3.4 Instrumentation and Control

STD DEP T1 3.4-1

Figure 3.4a Safety System Logic and Control (SSLC) Control Interface Diagram

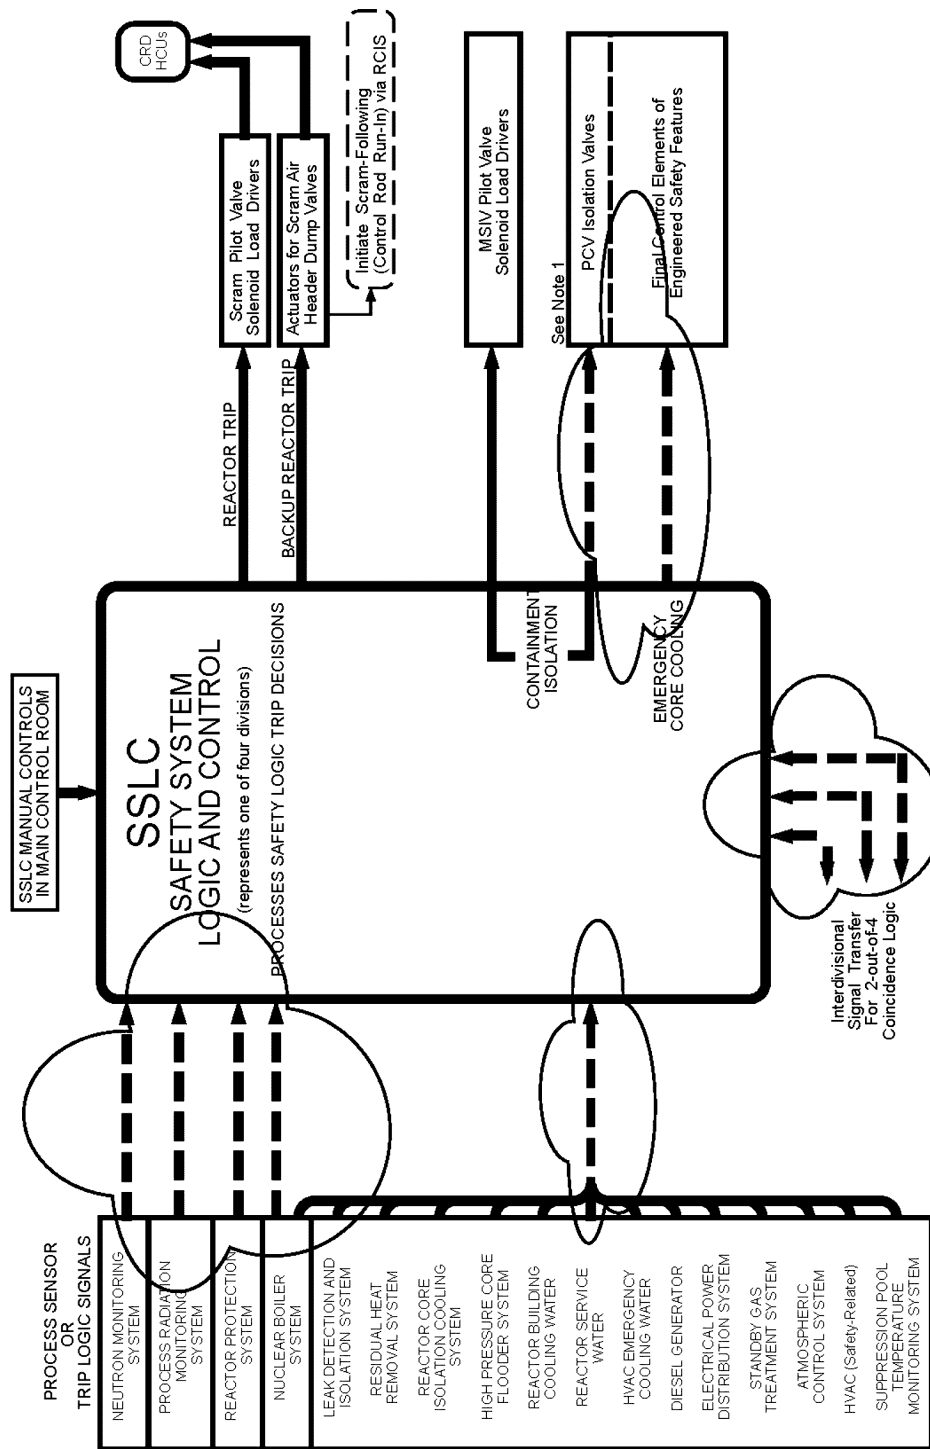
~~Safety-related monitoring and trip logic for the plant protection systems resides in SSLC equipment. SSLC integrates the automatic decision-making and trip logic functions and manual operator initiation functions associated with the safety actions of the safety-related systems.~~ Safety System Logic and Control (SSLC) is a general term that encompasses the logic and controls associated with safety-related systems. This includes automatic and manual protection and control functions. SSLC generates the protective function signals that activate reactor trip and provide safety-related mitigation of reactor accidents. SSLC is primarily implemented through the Reactor Trip and Isolation System (RTIS), which supports the reactor protection and main steam isolation functions, and the ESF Logic and Control System (ELCS), which supports the accident mitigation functions. Also included in SSLC are the Neutron Monitoring System (NMS), the Containment Monitoring System (CMS) and the safety-related portions of the radiation monitoring systems. The relationship between SSLC and systems for plant protection is shown in Figure 3.4a.

Figure 3.4b Safety System Logic & Control Block Diagram

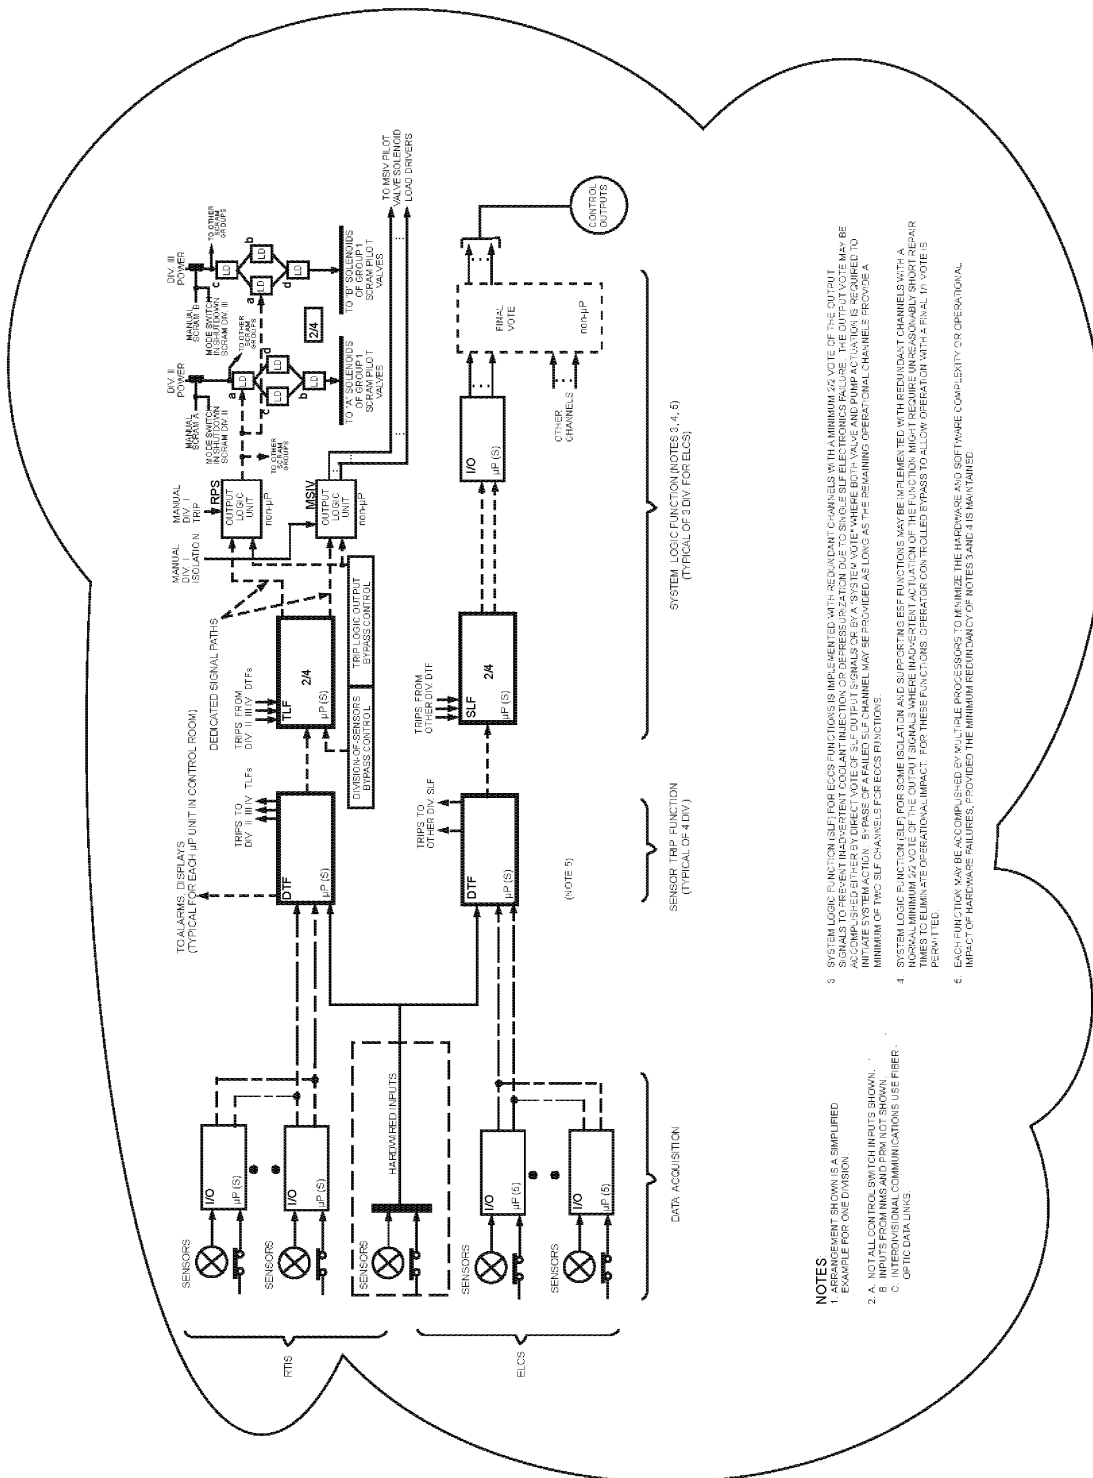
The basic ~~hardware~~functional configuration for one division of SSLC is shown in Figure 3.4b. Each division runs independently (i.e., asynchronously) with respect to the other divisions. The following steps describe the processing sequence and associated function descriptions for incoming sensor signals and outgoing control signals. These steps are performed simultaneously and independently in each of the four divisions:

As shown in Figure 3.4b, a pair of SLU are located in each of two engineered safety feature (ESF) processing channels, ESF1 and ESF2. ESF1 processes initiation logic for functions which service the reactor vessel at low pressure (e.g. RHR), while ESF2 provides the same support for the vessel at high pressure (e.g. Reactor Core Isolation Cooling (RCIC) System and High Pressure Core Flooder (HPCF) System). Associated LDS and ESF functions are also allocated to these logic channels.
